STAFF REPORT: 12-11-2019 MEETING

APPLICATION NUMBER: 19-6578

ADDRESS: 19650 STRATFORD

SCOPE: PARTIAL WINDOW REPLACEMENT ON SIDE AND REAR ELEVATIONS

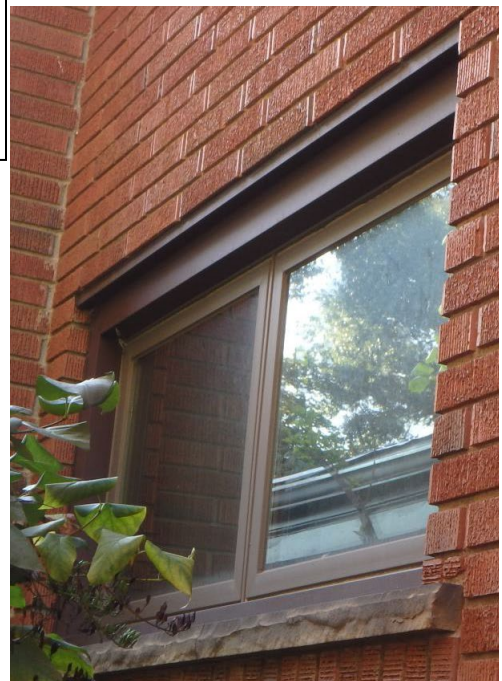
- The three double-sliders will be replaced to match the existing function.
- The four unit will be replaced with a three-part sliding window, which will break the rhythm established by the remaining of window openings.
- The neighboring properties are close to the applicant's property, reducing the visibility of the side windows (and two are on the rear elevation).
- The proposed color matches one of the colors within Color System E, which is used for Prairie-style architecture and looks to be a close match to the color of the remaining casement and slider windows.
- The new windows will not have storm windows.

- The removal of the silver aluminum storm windows would be a positive change.

The size of the new frames will not match the existing frames. As Renewal by Anderson is specific to the Fibrex material, there are no other options within the replacement system that could offer a thinner frame.

Width of Frames	Existing	Proposed	Difference
Side Jam	2 - ½ ”	3 - 0”	20% larger
Meeting Rail	1 - ½ ”	2 - 1/16 ”	33% larger

Height of Frames	Existing	Proposed	Difference
Head Jamb	2 – 0”	3 – 1/8”	50% larger
Bottom	2 – 0”	3 – 7/8”	100% larger

It is staff’s opinion the removal of the four original sliding windows and installation of Renewal by Anderson Fibrex replacement sliding windows will alter features that characterize the property. The frame width for the proposed windows is too great and will not only reduce the glass size within each window, the thick frames will create a heavier appearance for each window opening.

Therefore staff recommends the Commission deny a COA for the four window replacements as they do not meet the following Secretary of the Interiors Standards for Rehabilitation, especially:

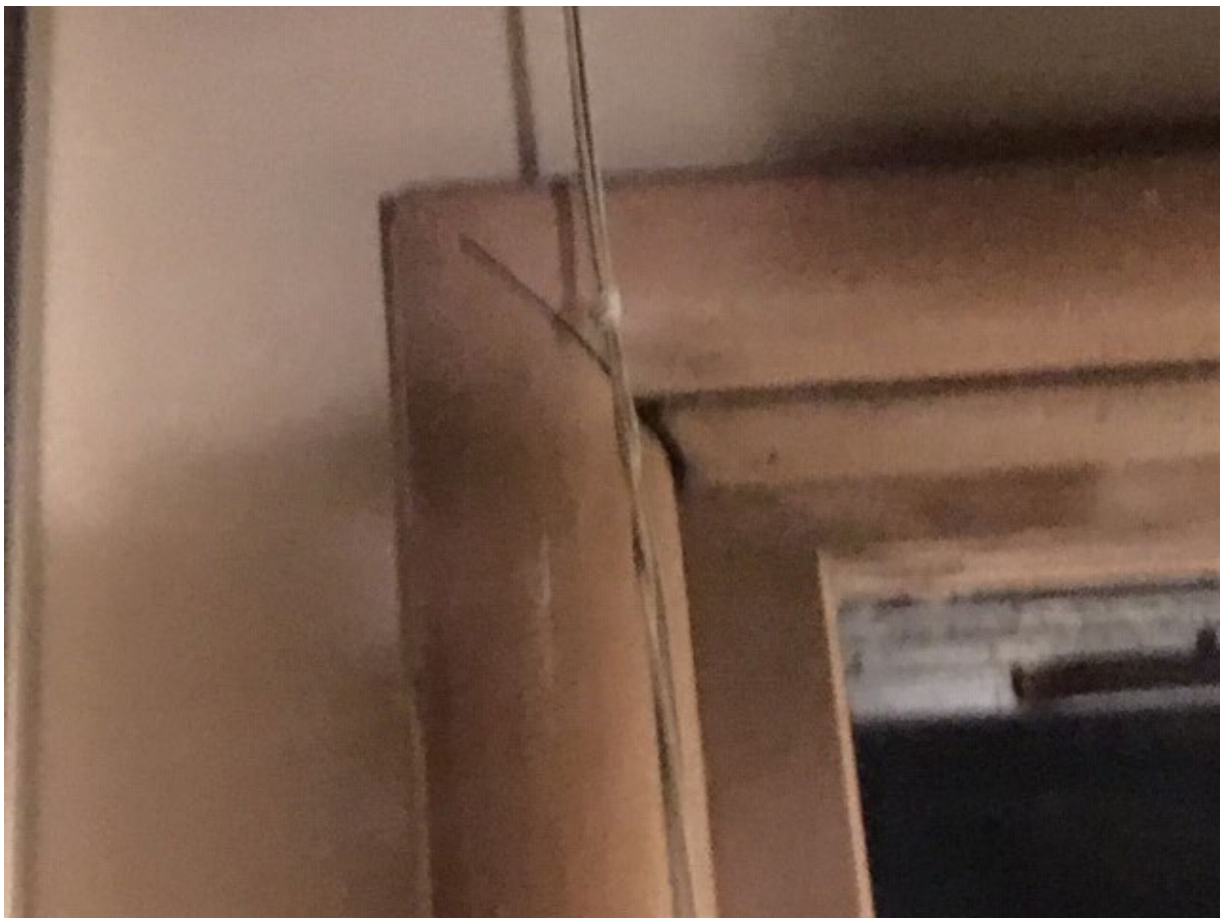
In looking at the photos sent it appears as though the window frames are out of square. Which is why air is getting around the sash, also separation at the interior corners of main frame indicates the frame is under pressure and twisting. This is most commonly caused by interior structure frame lowering (settlement) and exterior wall surface is not, house is trying to slide window down behind sill causing a "crowning" problem.

Unfortunately the cost of repairs would most likely exceed replacement cost and you would still have same old window framing.

UNIT 201,
203, 204
CURRENT
WINDOW

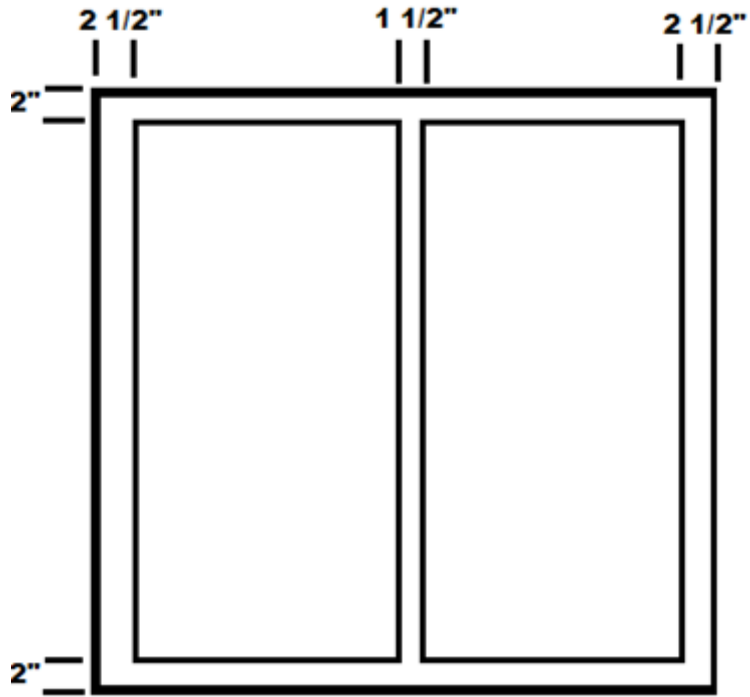
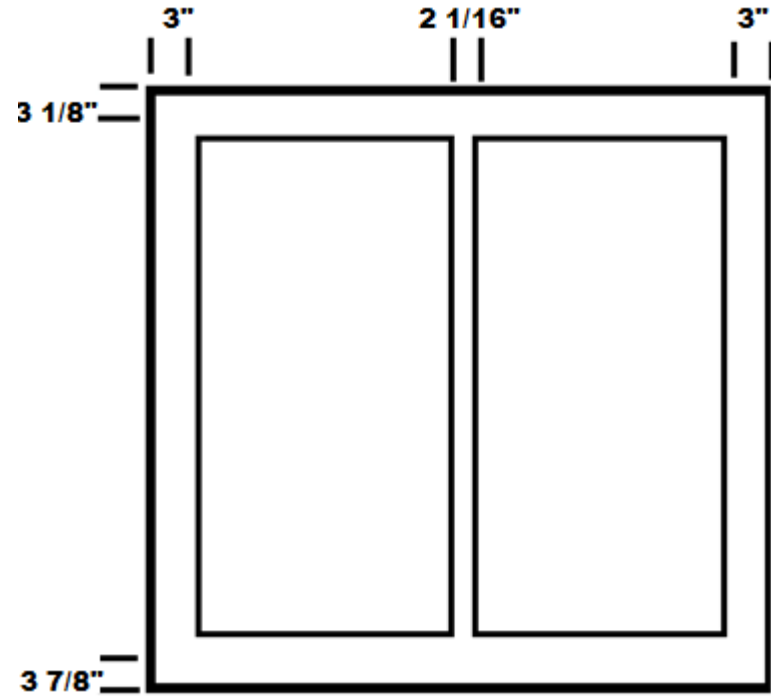
UNIT 201
Matching gliding window style, no grilles.

UNIT 203
Matching gliding window style, no grilles.

UNIT 204
Matching gliding window
style, no grilles.

UNIT 202
CURRENT
WINDOW

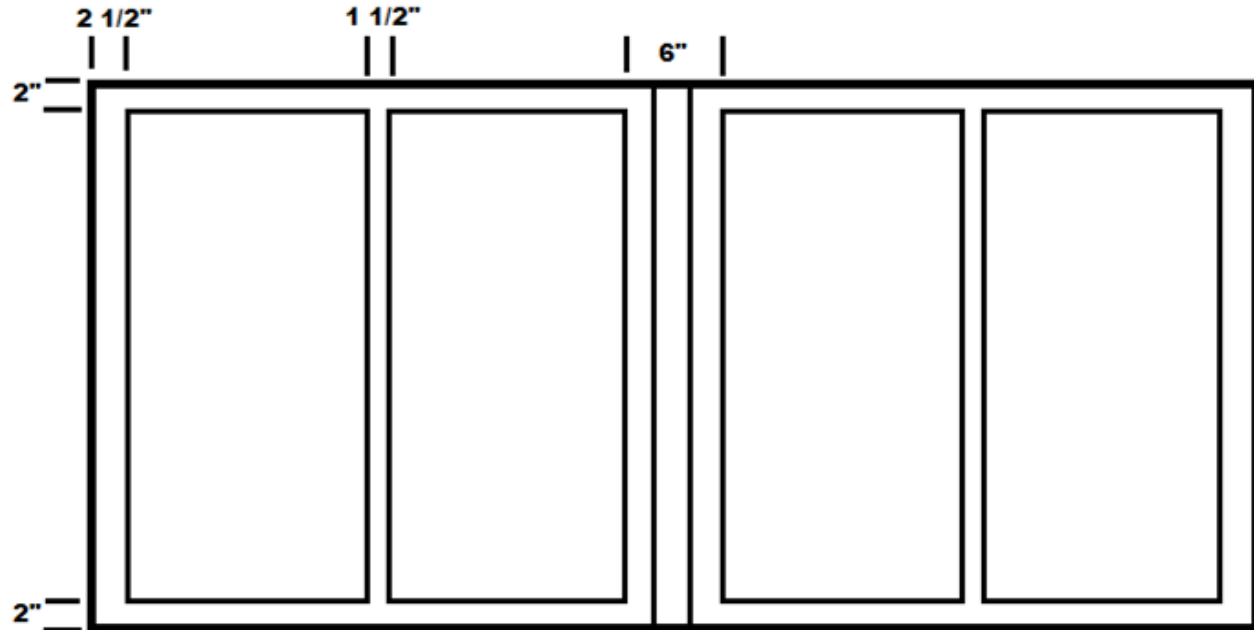
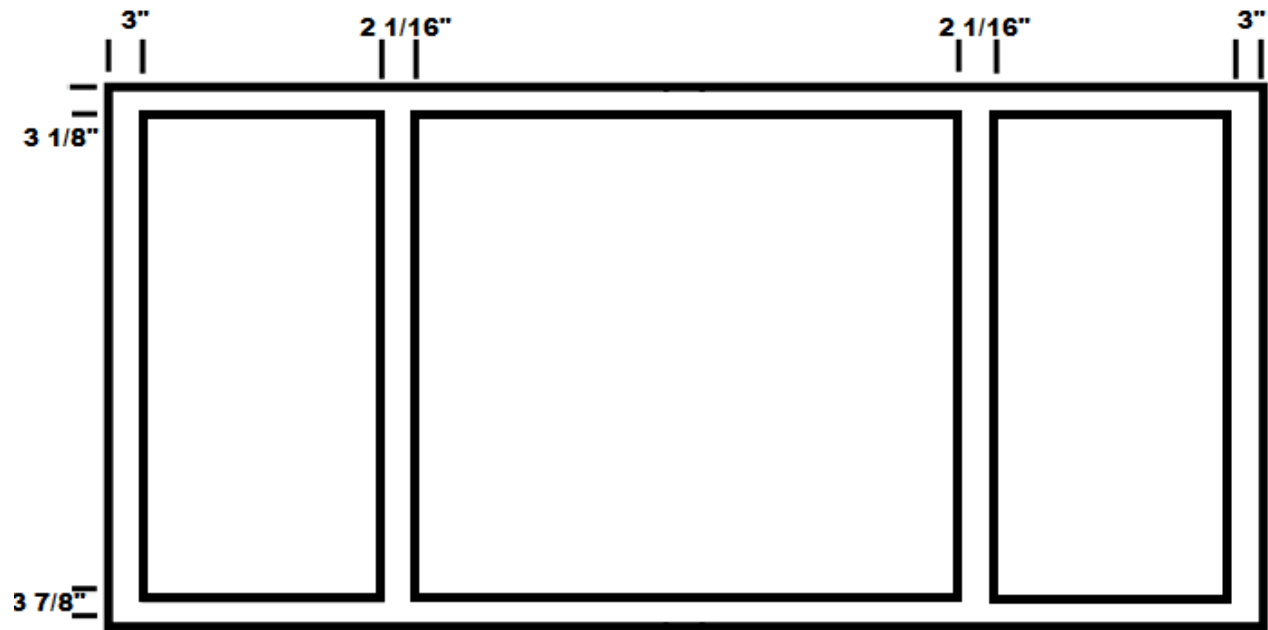
Unit 202
Replacing two gliding windows with one large 3 panel (1:2:1) gliding window
